NOTICE OF A TYPE II DECISION ON A PROPOSAL IN YOUR NEIGHBORHOOD

CASE FILE NUMBER: LU 16-198884 AD

Proposal: A “change of occupancy” building permit application for this site (permit no. 16-132801 CO) triggered a requirement in Zoning Code Section 33.266.130.G.2 for new 5-foot-wide landscaping buffers on the north, west, and south perimeters of the existing parking lot. The applicant is requesting approval of an Adjustment to reduce the required landscaping buffer on the north and south perimeters of the parking lot from 5 feet wide to zero. The applicant proposes a 12-foot-wide landscaping buffer on the west perimeter of the parking lot,

Exhibit C-1

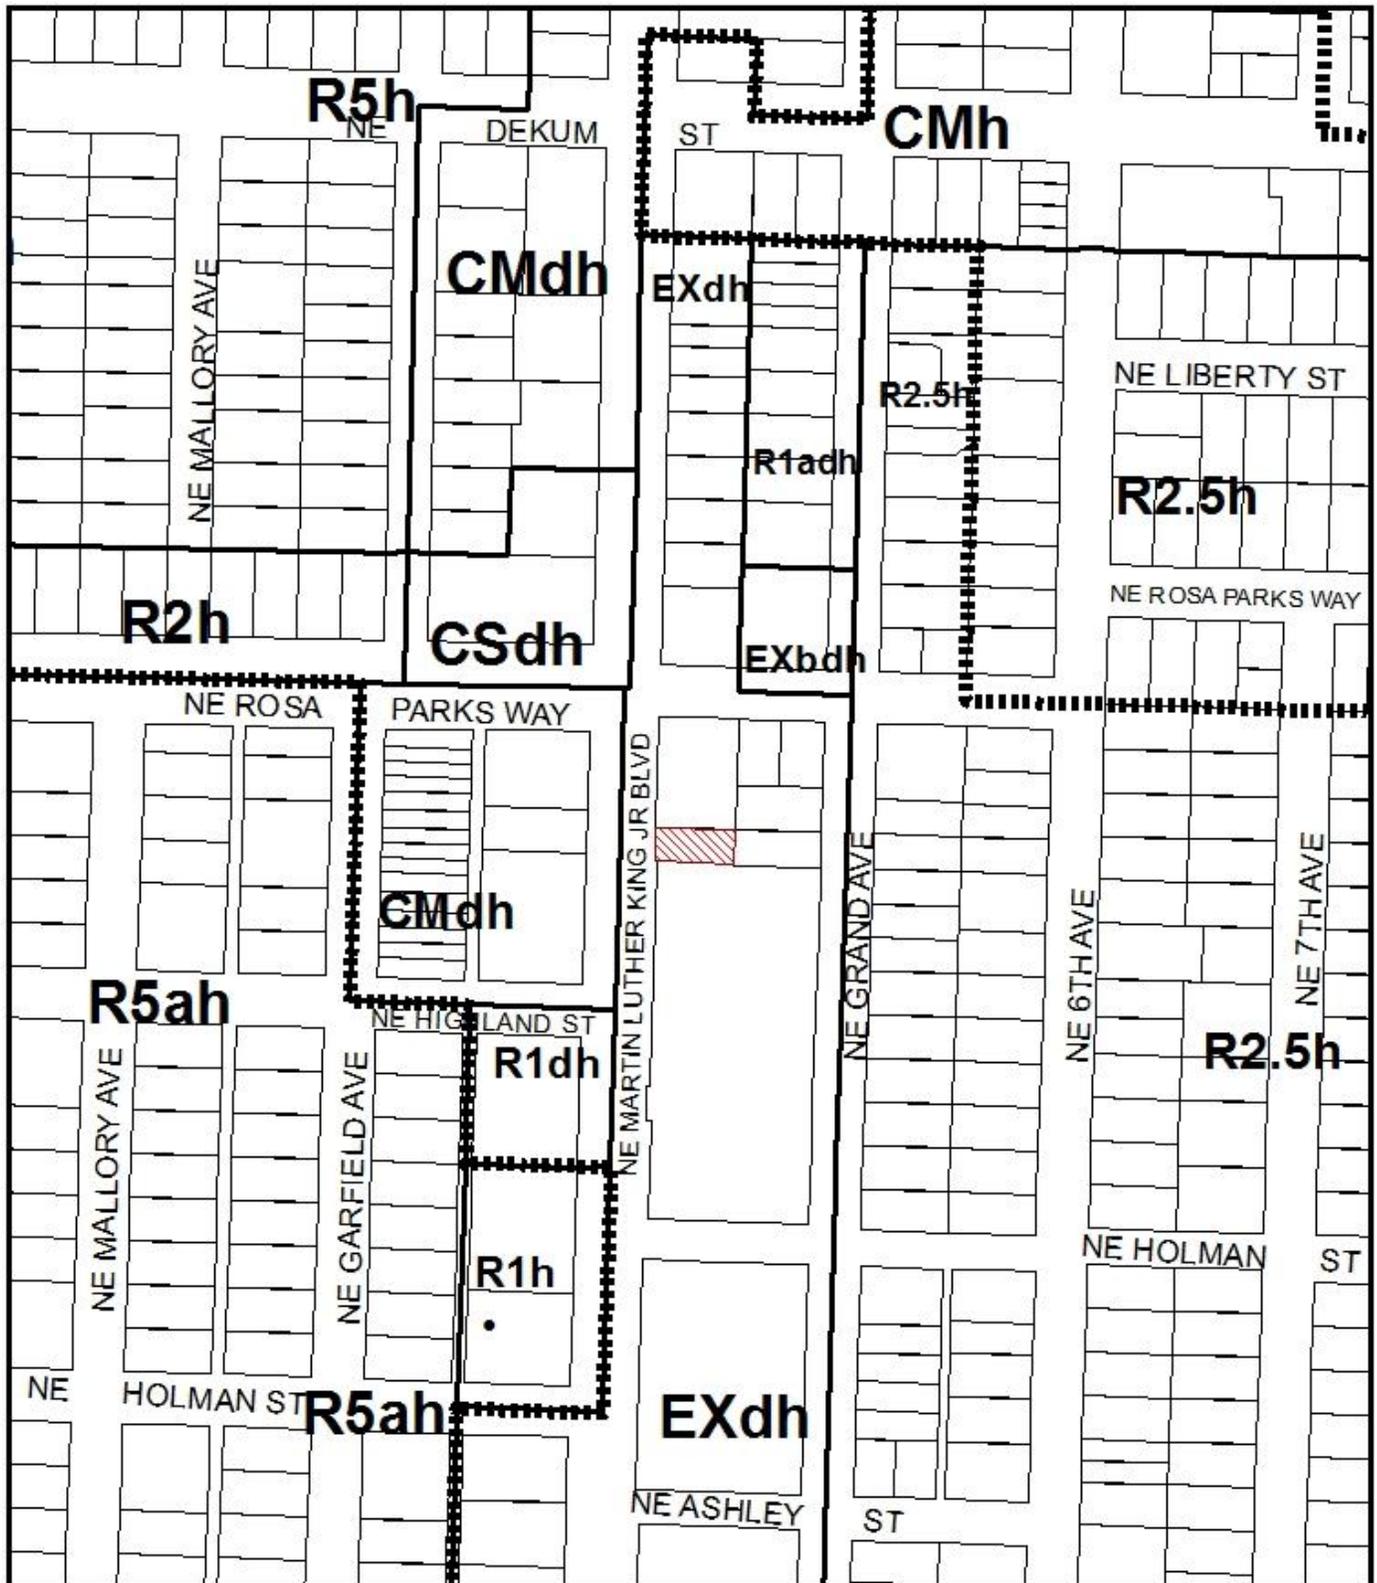
However, staff finds the *Viburnum tinus* shrubs proposed to surround the new incense cedar trees (Exhibit C-1) would be too tall (at 6 to 7 feet in height) to fit well within the

landscaping buffers. Shrubs this tall are not required by the L2 (low screen) landscaping standard that the Zoning Code requires for parking lots abutting streets (Zoning Code Table 266-5), and they would likely blend with the canopies of the incense cedars to create a crowded, fortress-like appearance from the street. Since staff finds the aesthetics would be softer and more appealing with lower shrubs, a condition of approval will require the *Viburnum tinus* shrubs to be replaced with a lower shrub variety that will be between 3 and 4 feet in height at maturity.

Also, staff doesn't find the applicant's proposal to install a new F2 (fully sight-obscuring) fence along the south lot line (Exhibit C-1) to be necessary to further the purposes of the landscaping standard, since the existing fence is already partially sight-obscuring, and an existing 10-foot-wide, densely-planted landscaping screen on the neighboring property abuts the south lot line. A new fence may be installed if desired, but will not be required as a condition of the Adjustment approval.

(new fence is optional - existing fence may remain unchanged if desired)

(Viburnum tinus shrubs must be replaced with a lower shrub variety per condition B.)

- A. As part of the building permit application submittal, each of the required site plans and any additional drawings must reflect the information and design approved by this land use review as indicated in Exhibits C-1 and C-2, except as modified by Condition B, below. The sheets on which this information appears must be labeled, "Proposal and design as approved in Case File # LU 16-198884 AD."
- B. The *Viburnum tinus* shrubs illustrated in Exhibits C-1 and C-2 must be replaced with a lower shrub variety that will reach at least 3 feet but not more than 4 feet in height at maturity.
